**Draft changes to clause 95 including  
TxVEC – rev3  
(with changes agreed in June 12<sup>th</sup> ad hoc)**

MMF ad hoc working document  
Jonathan King

**Figure 95–3—TxVEC conformance test block diagram**

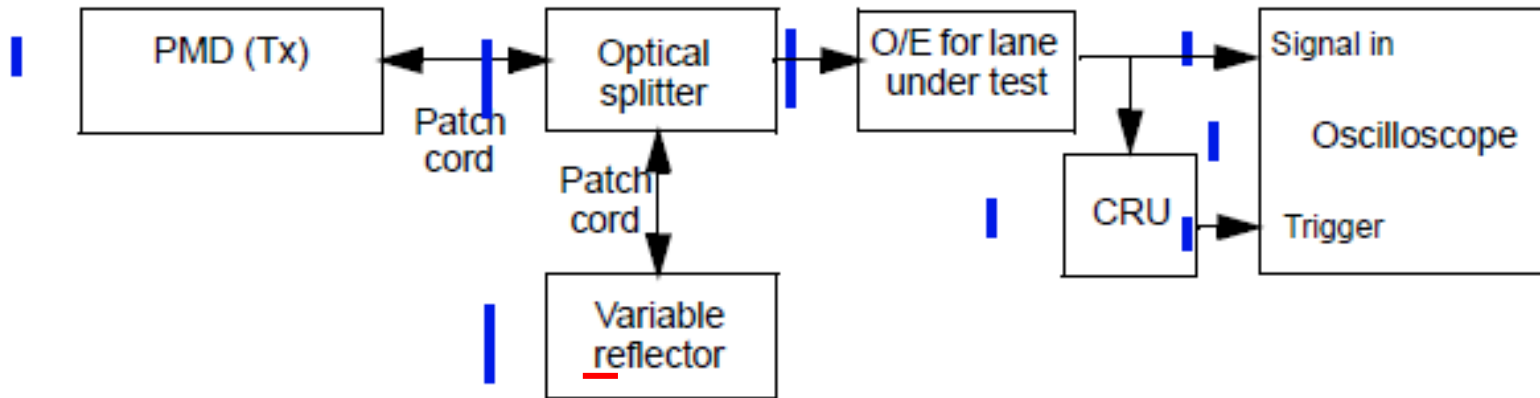
## 95.8.5.1 TxVEC conformance test set-up

A block diagram for the TxVEC conformance test is shown in Figure 95–3. Other measurement

implementations may be used with suitable calibration.

Each optical lane is tested individually with all other lanes in operation. The optical splitter and variable reflector are adjusted so that each transmitter is tested with an optical return loss of 12 dB.

The combination of the O/E and the oscilloscope used to measure the optical waveform has a fourth-order Bessel-Thomson filter response with a bandwidth of 12.6 GHz. Compensation may be made for any deviation from an ideal fourth-order Bessel-Thomson response.

The clock recovery unit (CRU) has a corner frequency of 10 MHz and a slope of 20 dB/decade.

Figure 95-4—Illustration of the TxVEC measurement

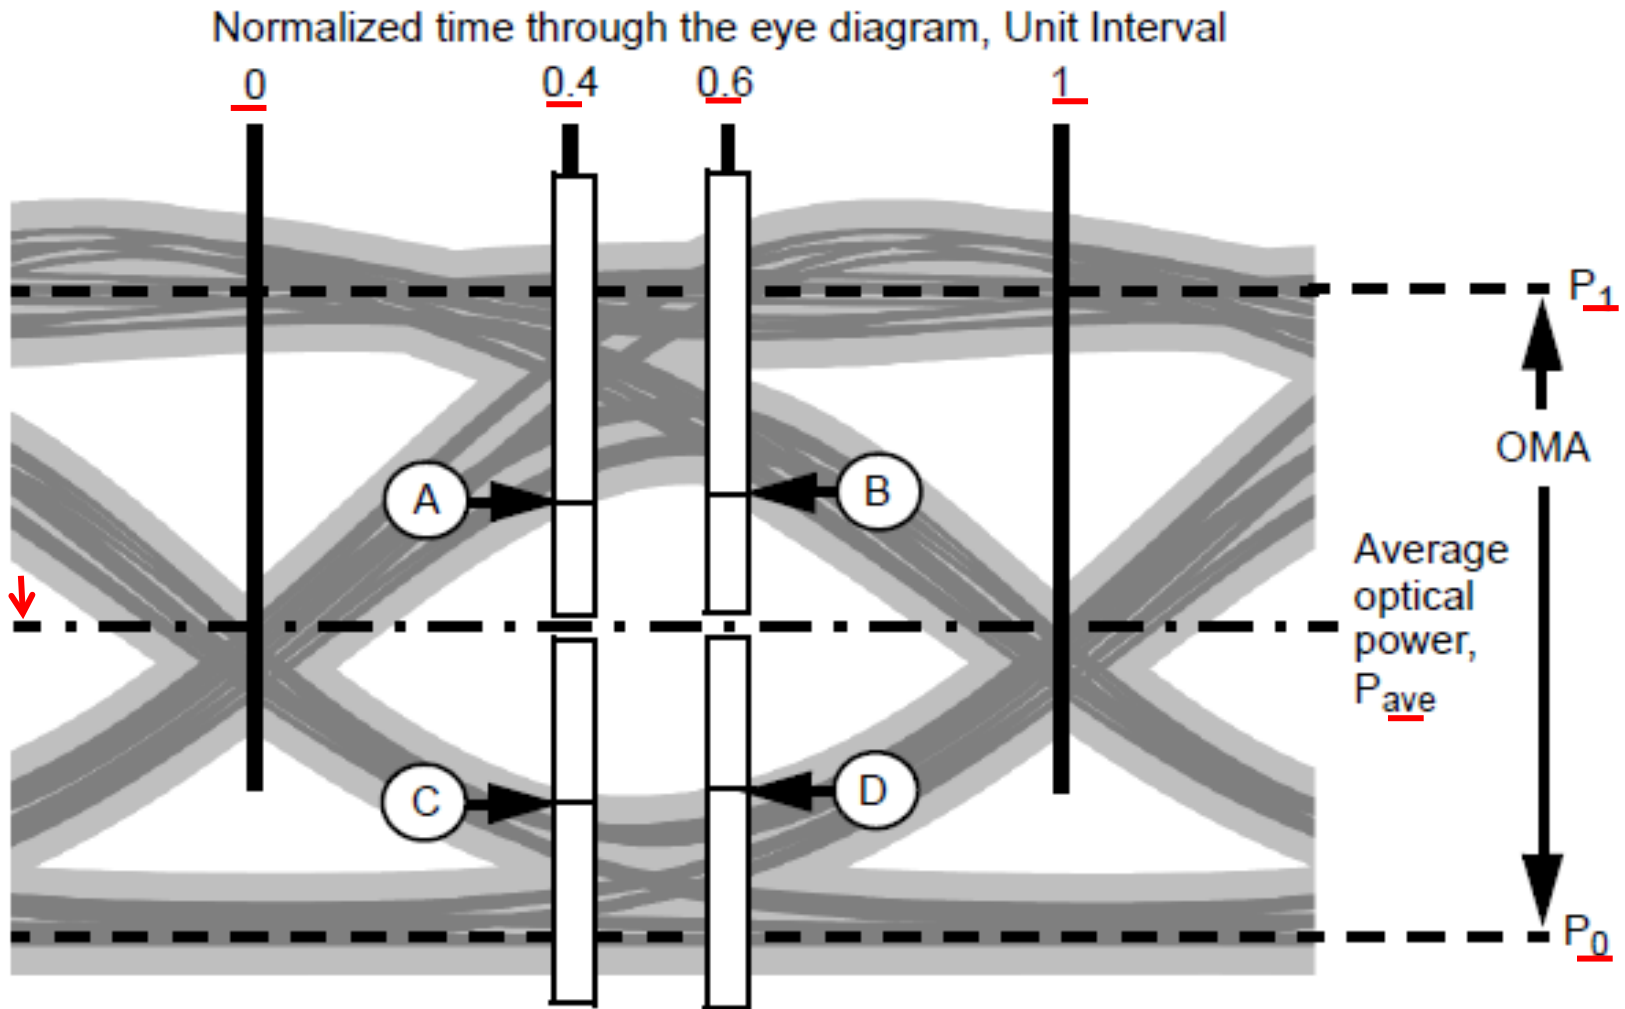
The oscilloscope is set up to accumulate samples of the optical eye diagram for the transmitter under test, as illustrated in Figure 95–4.

The 0 UI and 1 UI crossing points are determined by the time average of the eye diagram crossing points, as measured at  $P_{ave}$ , as illustrated in Figure 95–4.

Four vertical histograms are measured through the eye diagram, centered at 0.4 UI and 0.6 UI, and above and below  $P_{ave}$ , as illustrated in Figure 95–4.

Each histogram window has a width of 0.04 UI. Each histogram window has an inner height boundary which is set close to  $P_{ave}$  (so that no further samples would be captured by moving it closer to  $P_{ave}$ ), and an outer height boundary which is set beyond the outer-most samples of the eye diagram, so that no further samples would be captured by increasing the outer boundary of the histogram. Starting from the boundaries closest to  $P_{ave}$ , the power at which the cumulative distribution of each histogram equals the 0.005th percentile of the total number of samples in the histogram is determined (these are the powers A, B, C, and D, illustrated in Figure 95–4).
